# UNITED STATES PATENT AND TRADEMARK OFFICE

APPLICATION NO.	FILING DATE	FIRST NAMED INVENTOR	ATTORNEY DOCKET NO.	CONFIRMATION NO.
09/898,469	07/05/2001	Gang Paul Chen	ChenInterleave	8152
23294	7590	12/08/2003	EXAMINER	
JONES, TULLAR & COOPER, P.C. P.O. BOX 2266 EADS STATION ARLINGTON, VA 22202			JUBA JR, JOHN	
			ART UNIT	PAPER NUMBER

<b>Office Action Summary</b>	Application No.	Applicant(s)	
	09/898,469	CHEN ET AL.	
	Examiner	Art Unit	
	John Juba	2872	<i>llw</i>

## **DETAILED ACTION**

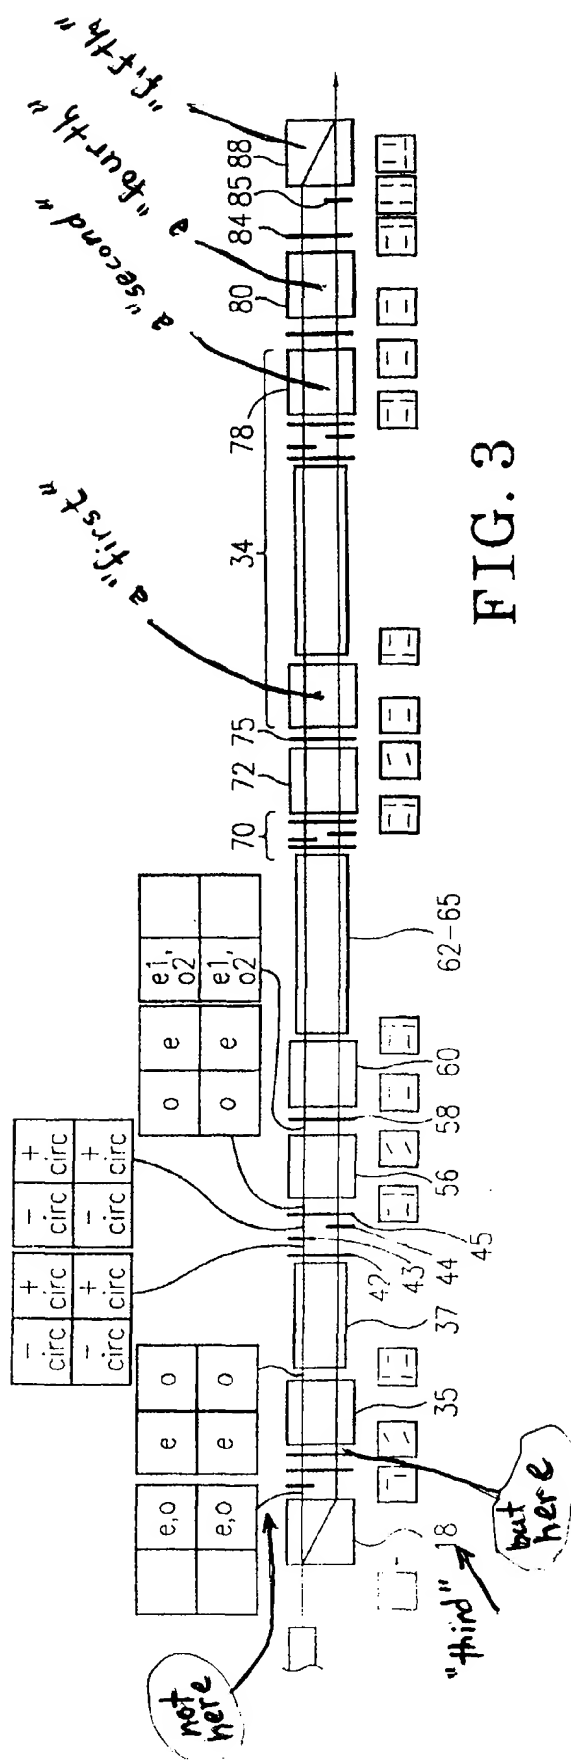
The function of beam splitter (72) and the beam splitter following wave plate (75) is believed to be mis-illustrated in Figure 2. See attached marked-up copy.

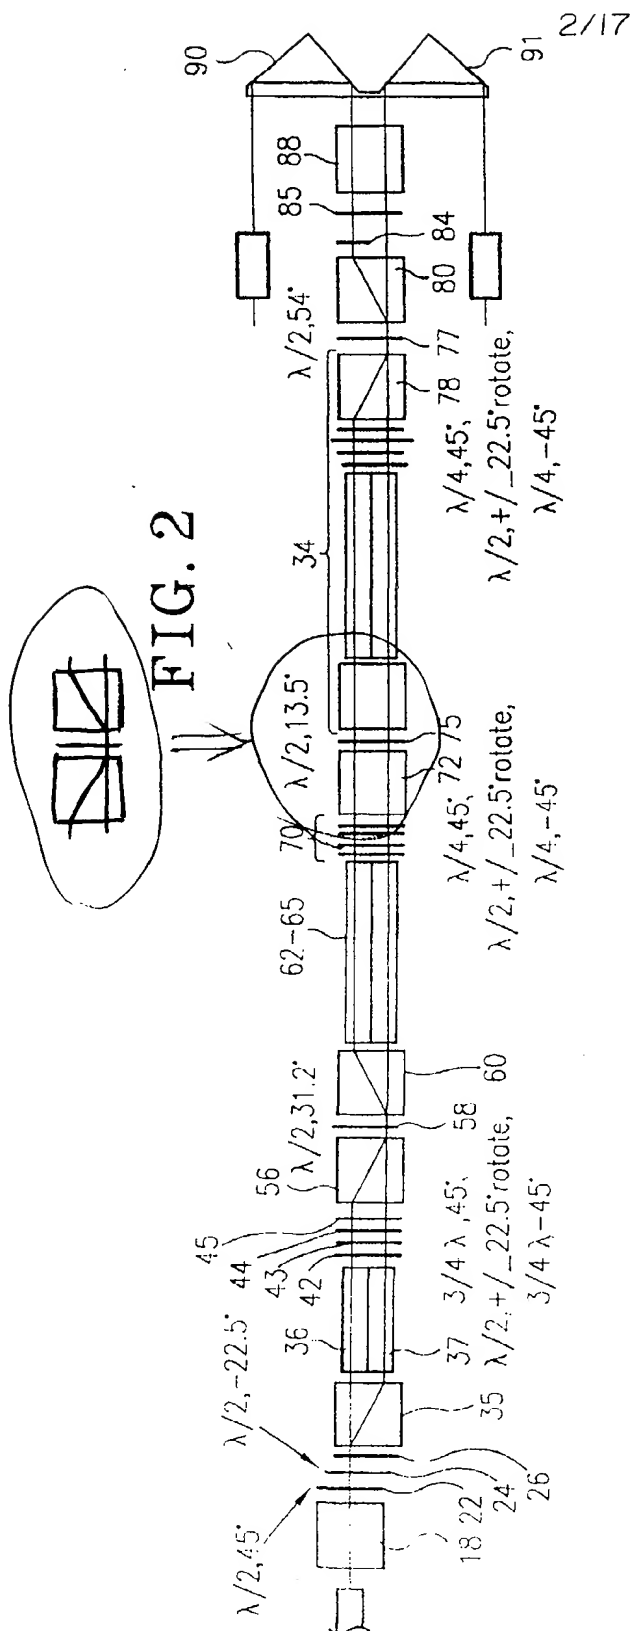
The lead line on the first state of polarization diagram in Figure 3 is believed to be misplaced. An appropriate location near beam splitter (35) is indicated in the attached marked-up copy of Figure 3.

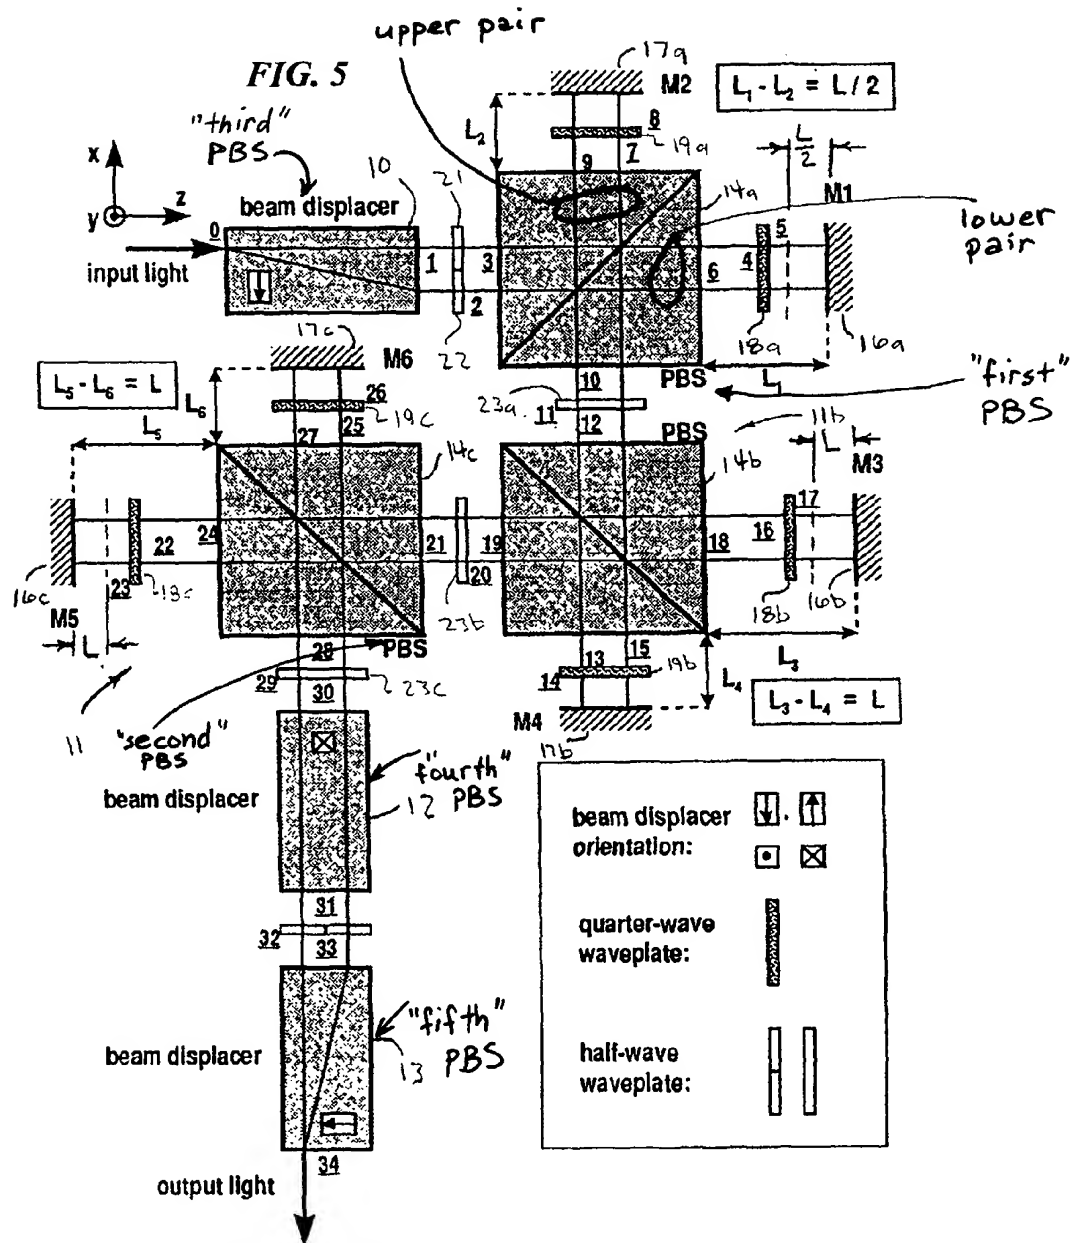
Claims 20, 24, 25, 29, 31, 42, 43, and 46 – 50 are rejected under 35 U.S.C. 102(e) as being anticipated by Zhao (U.S. Patent Application Pub. no. 2002/0048424 A1). Referring *for example* to the discussion of Figures 5 and 6, Zhao discloses first (14a), second (14c), third (10), fourth (12), fifth (13) polarizing beam splitters, the first and third beam splitter cooperating to divide an input beam into upper and lower orthogonally polarized beam pairs, as shown in the attached marked-up copy

of Figure 5. The assembly comprises a number of stages wherein the path length differences are integer multiples (1, 2, and 2) of the same value,  $L$ . Waveplates (23a) and (23b) are provided between stages to tailor the response. The characterization of the apparatus as "a microoptic element" is not seen as imparting any positive structural characteristic as would distinguish over the prior art, which has all of the positive recited structure. The provision of athermalized paths is discussed in paragraph [0075].
